**RE: SITE PLAN – ADMINISTRATIVE DEVELOPMENT FACILITATION TEAM
PR-2024-010691, SP-2025-00031
7520 RAINBOW BLVD NW; LT 11-A BLK 2 PLAT OF LTS 10-A, 11-A, 19-A THRU 22-A BLK
2 UNIT 14 VOLCANO CLIFFS SUBD CONT 2.0312 AC**

Please see responses to DFT comments for **PR-2024-010691, SP-2025-00031**.
Also included are the updated construction drawings to address the comments.

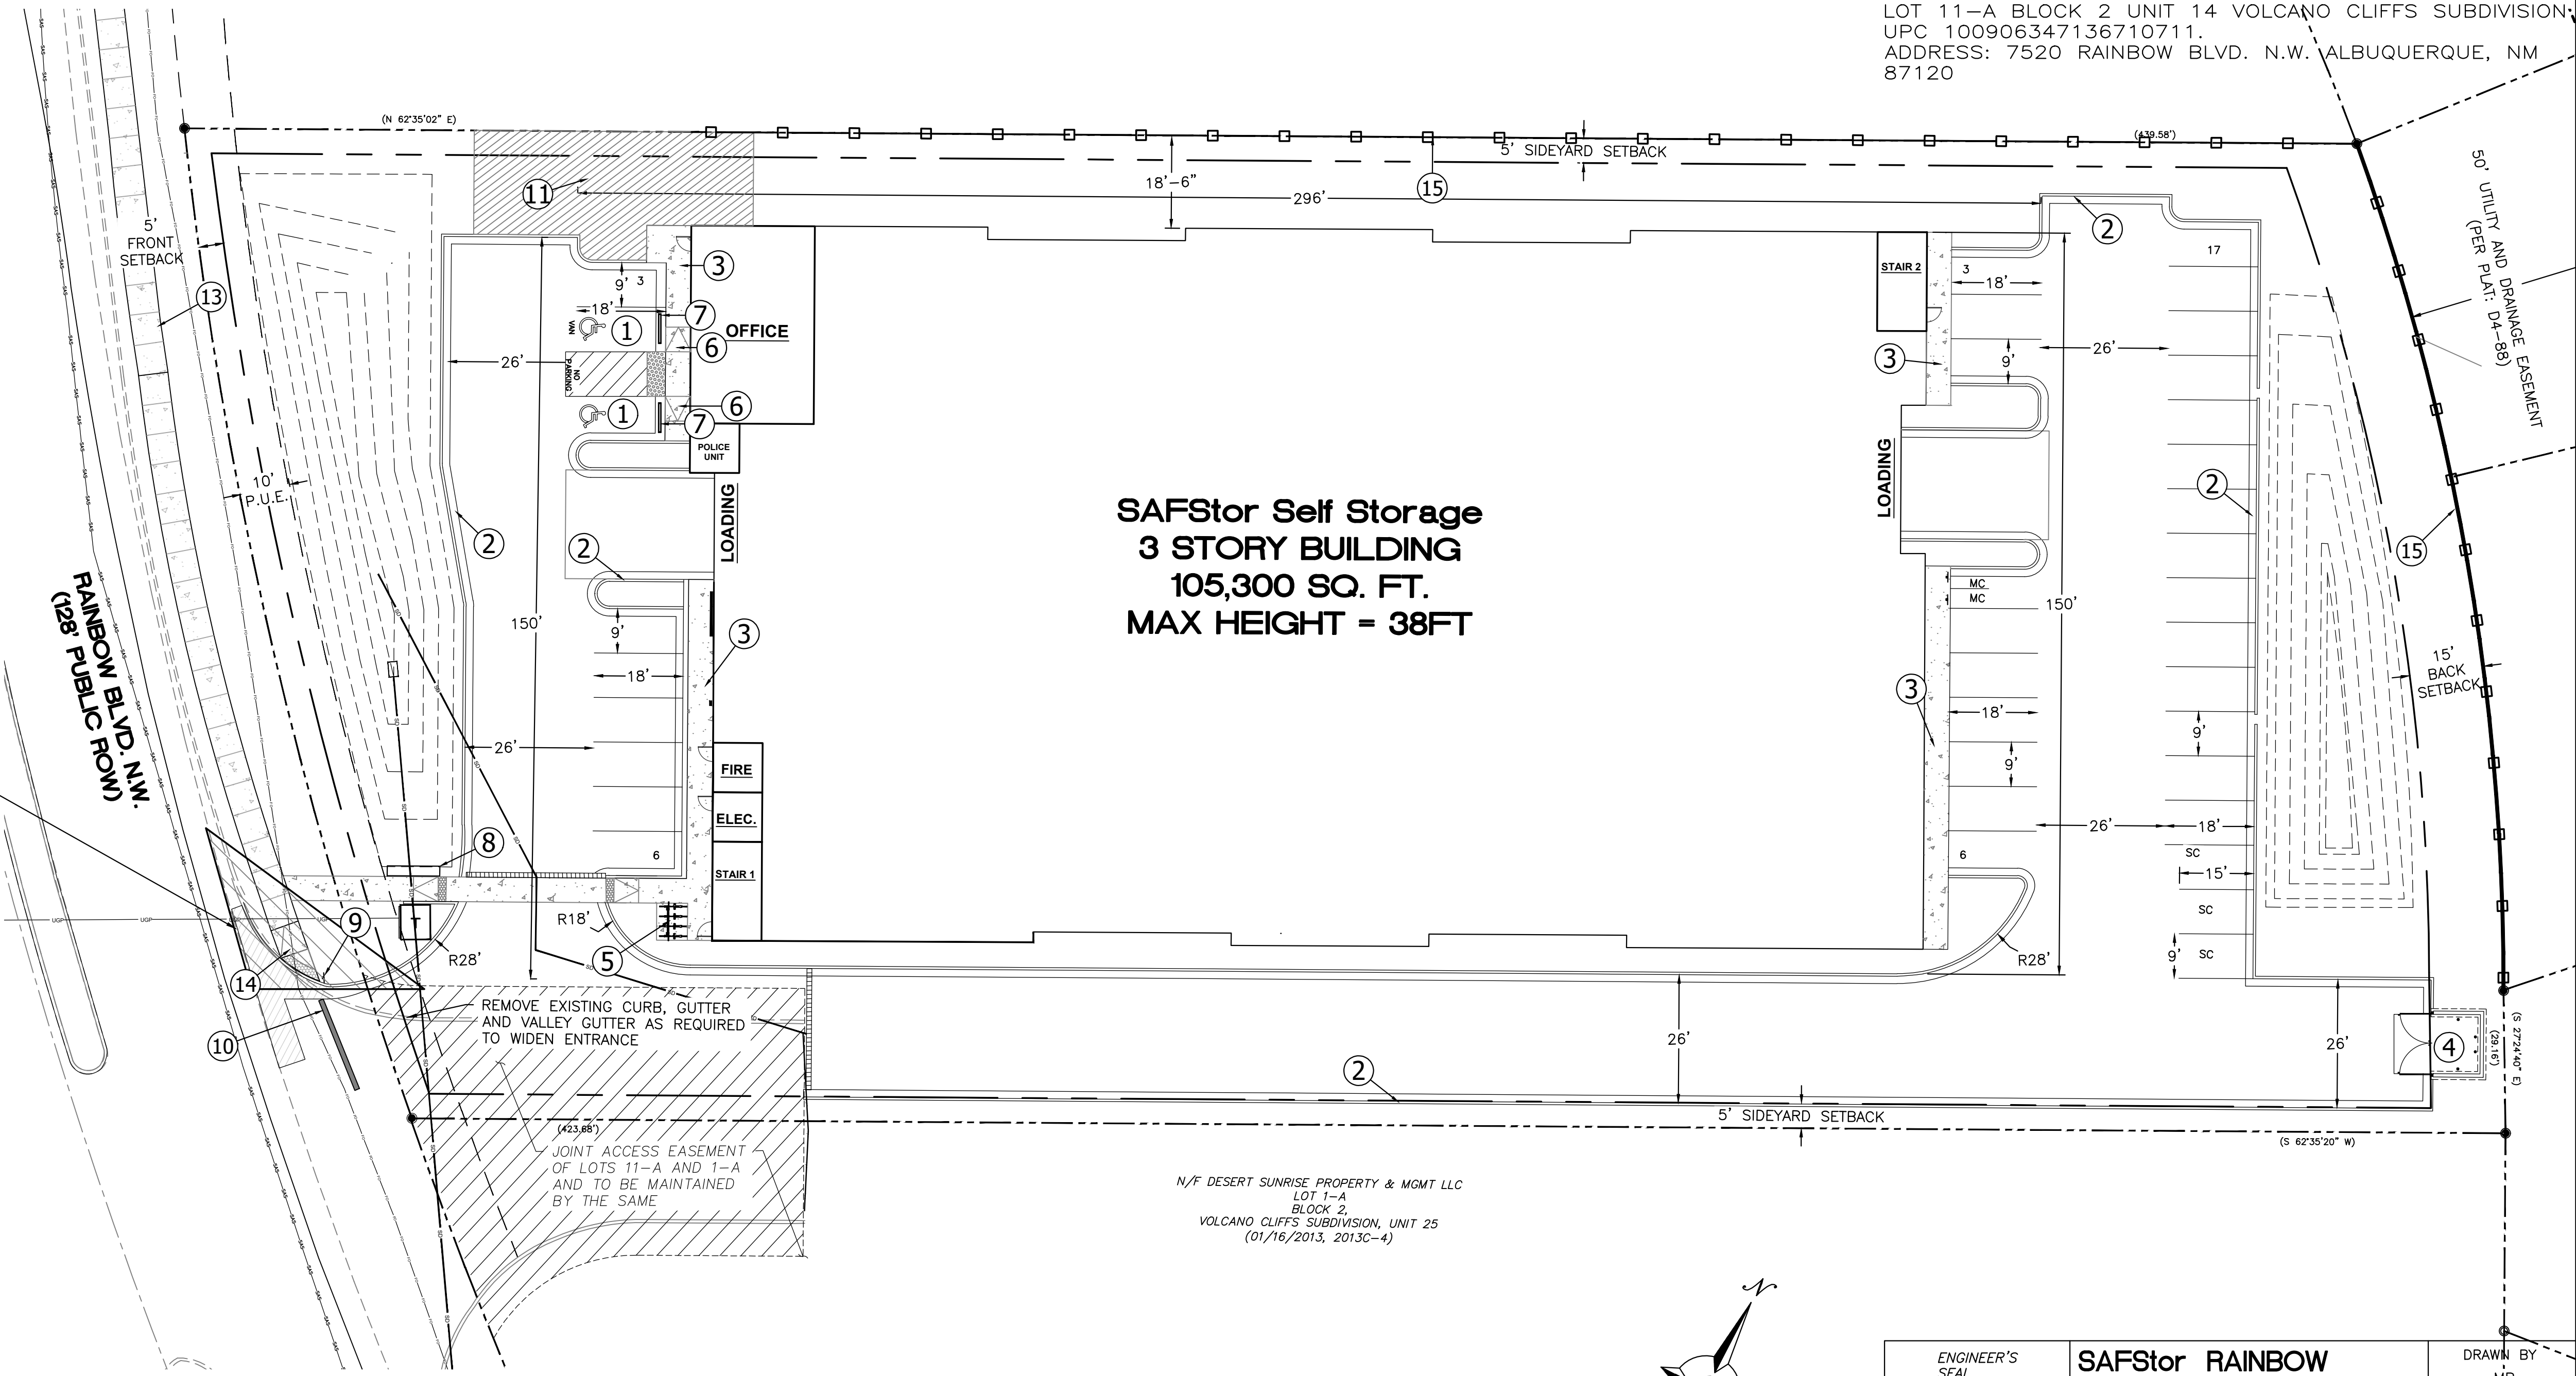
2. Please label the portion of public fire line within the right-of-way as “public” and note that it will be constructed with a work order or connection permit (as applies) as well as any other connections to the public water and/or sanitary sewer systems.

1. Self-Storage requires a conditional use approval in the MX-L zone district as specified in the allowable use table. A conditional use was approved October 02, 2024 and Notice of Decision (NOD) was submitted with this application. The site will also be subject to the requirements of the View Protection overlay Zone (VPO-2). * Plans will demonstrate how these standards are being met.

2. Clarify the Development/Dimensional standards per section 5-1-D, table 5-1-2 and section 3-6(E) Northwest Mesa Escarpment – (VPO-2) height standards.

5. Clarify and confirm that all development, landscaping, and screening are within private property areas and they will not be encroaching into the public right of way.

6. Confirm compliance with section 7 of the DPM Table 7.2.29 regarding Sidewalk width requirements, the landscape buffer, and Maintenance responsibilities.

- a. Rainbow Blvd. is a Principal Arterial Street and requires 6' sidewalk width a 5' to 6' landscape buffer. Please provide a dimension of sidewalks and buffers along the frontage. All work in the ROW needs to be placed on an infrastructure list and done

through City work order. *Verification of standards per Transportation. *Clarify if dedication of right of way is needed for either trail or sidewalk.

RESPONSE: This has been labeled

RESPONSE: Refer to SP, dimensions abide by the View Protection Overlay Zone (VPO-2)

RESPONSE: Refer to SP, dimensions abide by the Northwest Mesa Escarpment – (VPO-2) height standards. The site is not located within the Sub-VPO2 section.

RESPONSE: All development is within private property areas.

RESPONSE: Refer to SP dimensions

3
A201
EXTERIOR ELEVATION & PROFILE PLAN WEST
SCALE: 1" = 10'-0"

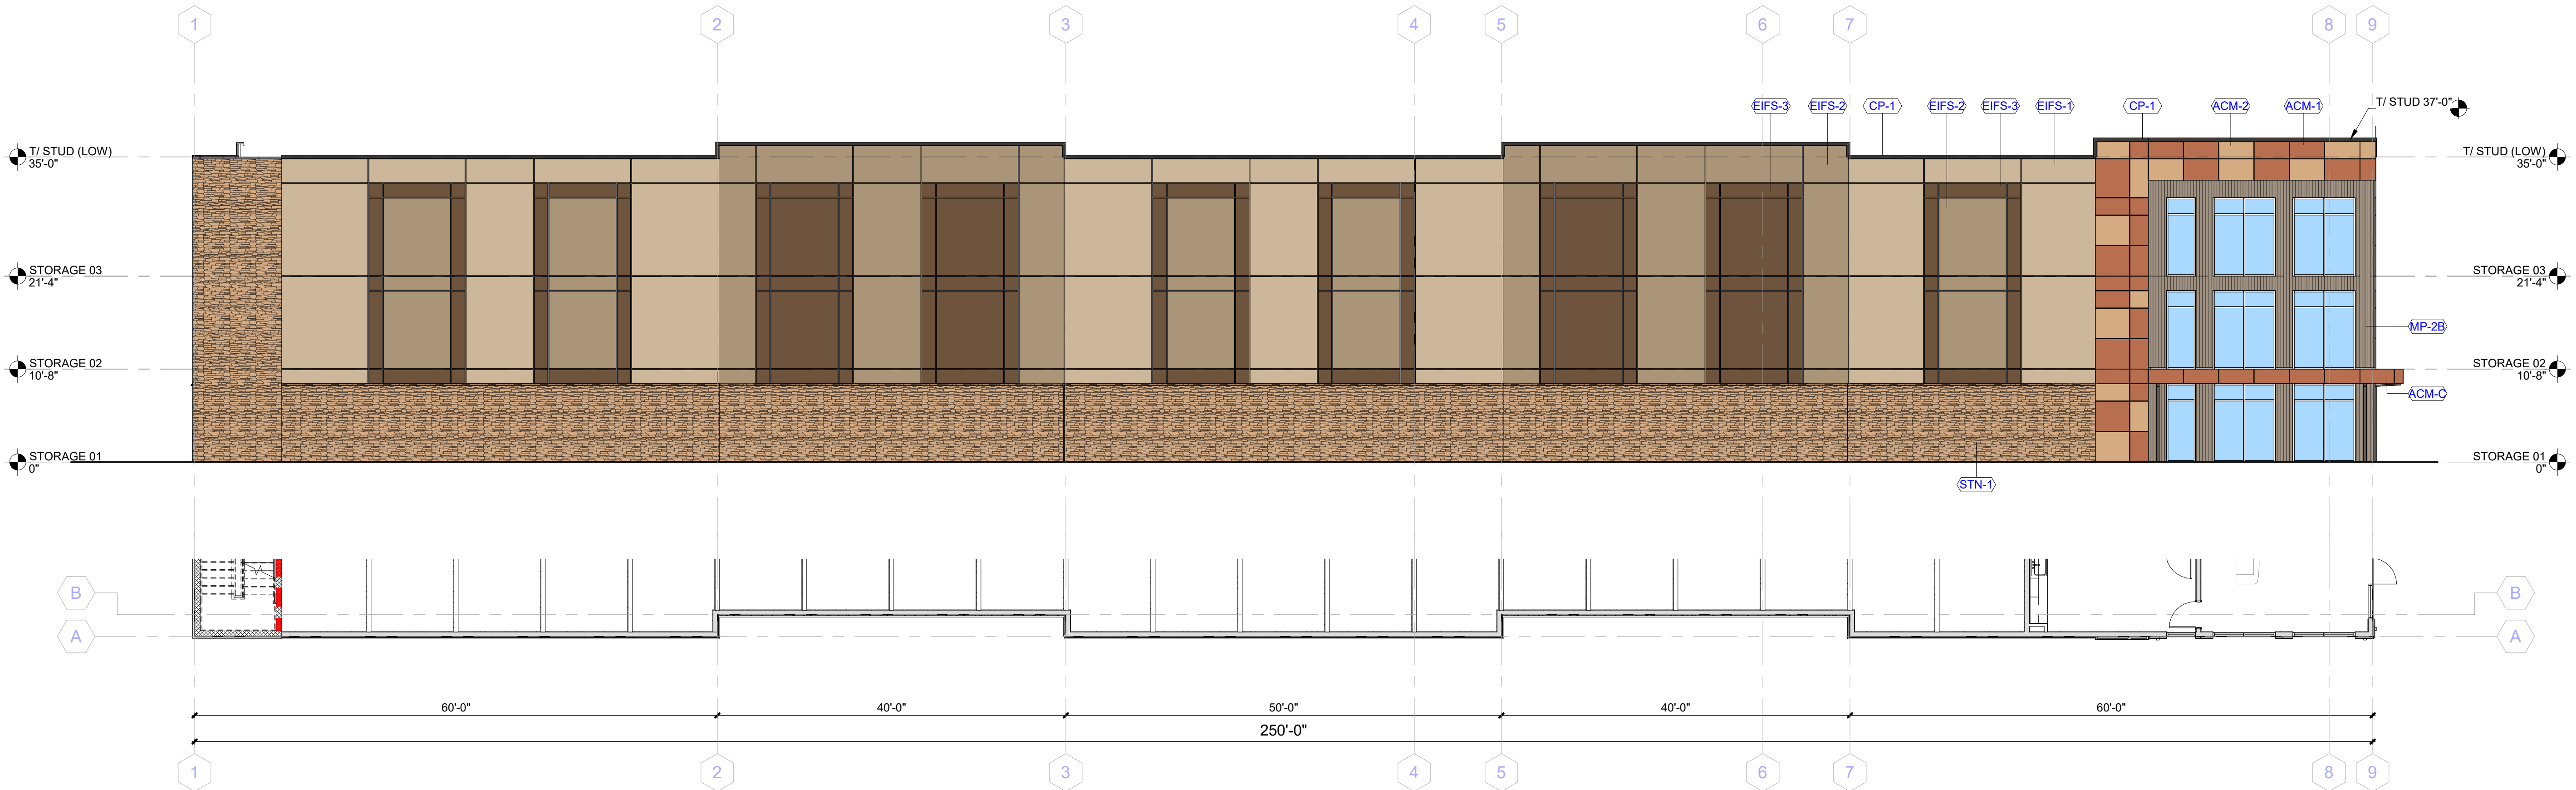
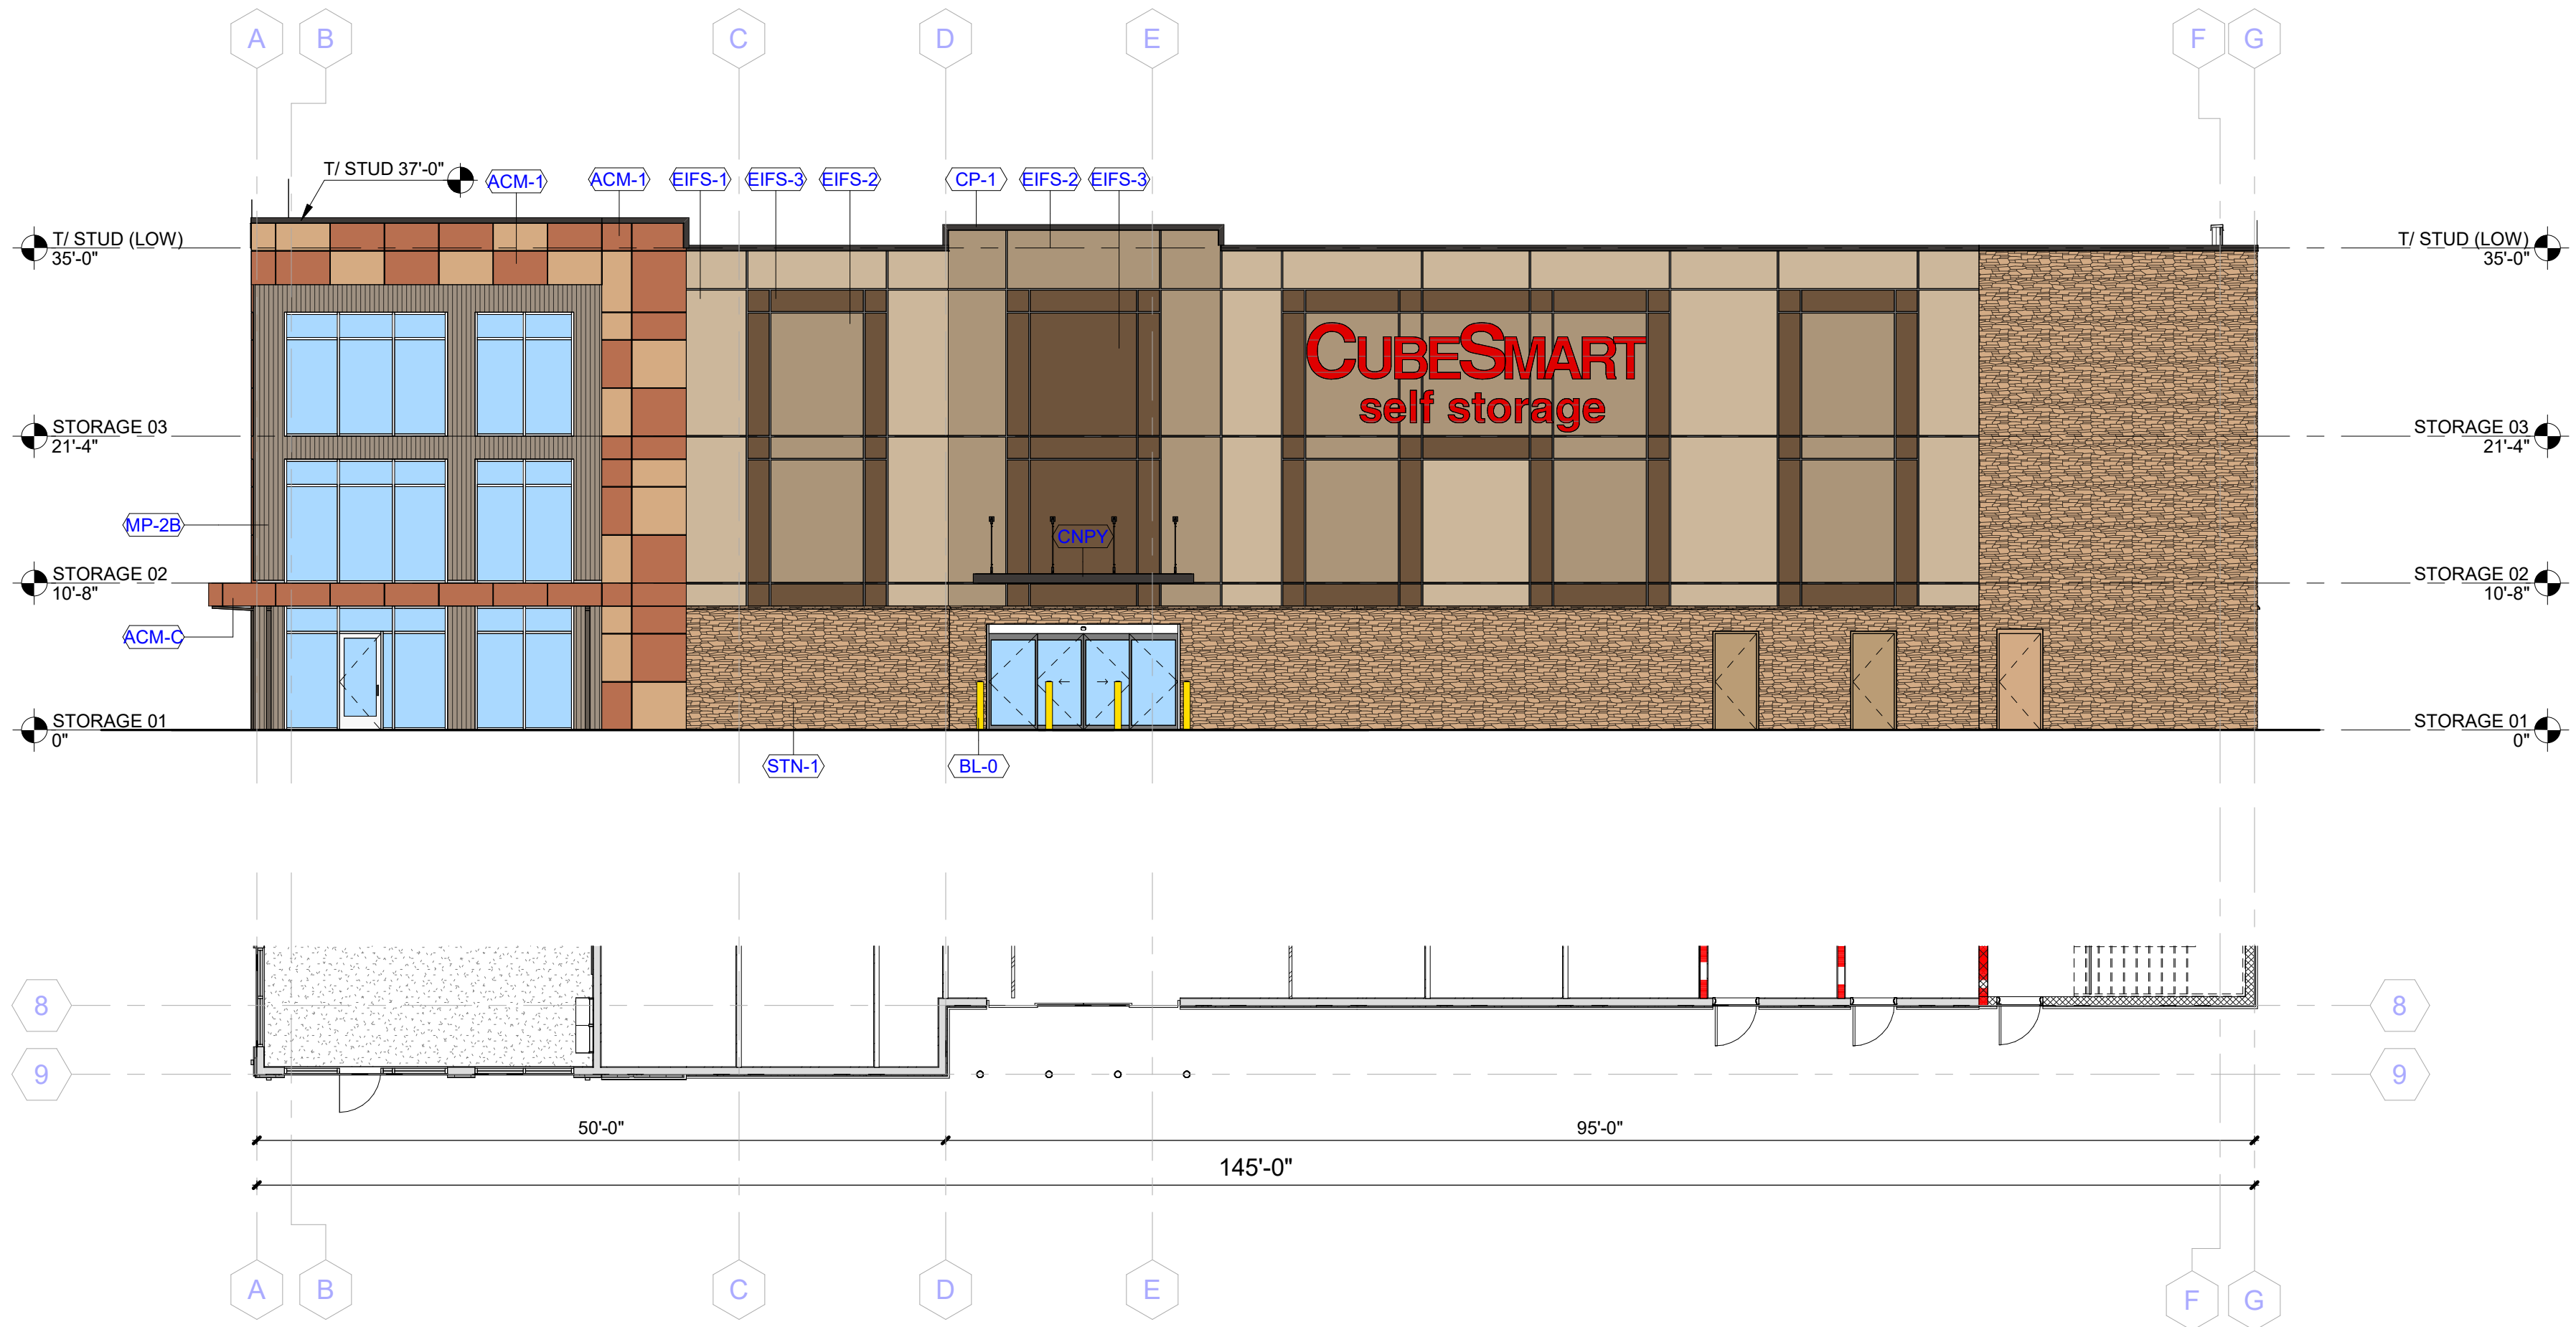
15. Elevation pages need to include details on how the project will be meeting IDO section 3-6-(E) Northwest Mesas Escarpment; specifically, 6-6(E)(5). Provide additional elevation detail to demonstrate and explain compliance with all sections within 5-11-E. Specifically 5-11-(E)(2) and 5-11(E)(3)(a)(2).

RESPONSE: See updated Elevation sheets highlighting color pallet from section 3-6(E)(5). All dimensional standards in section 3-6-(E), 5-11-(E)(2), and 5-11(E)(3)(a)(2) are met, see dimensions.
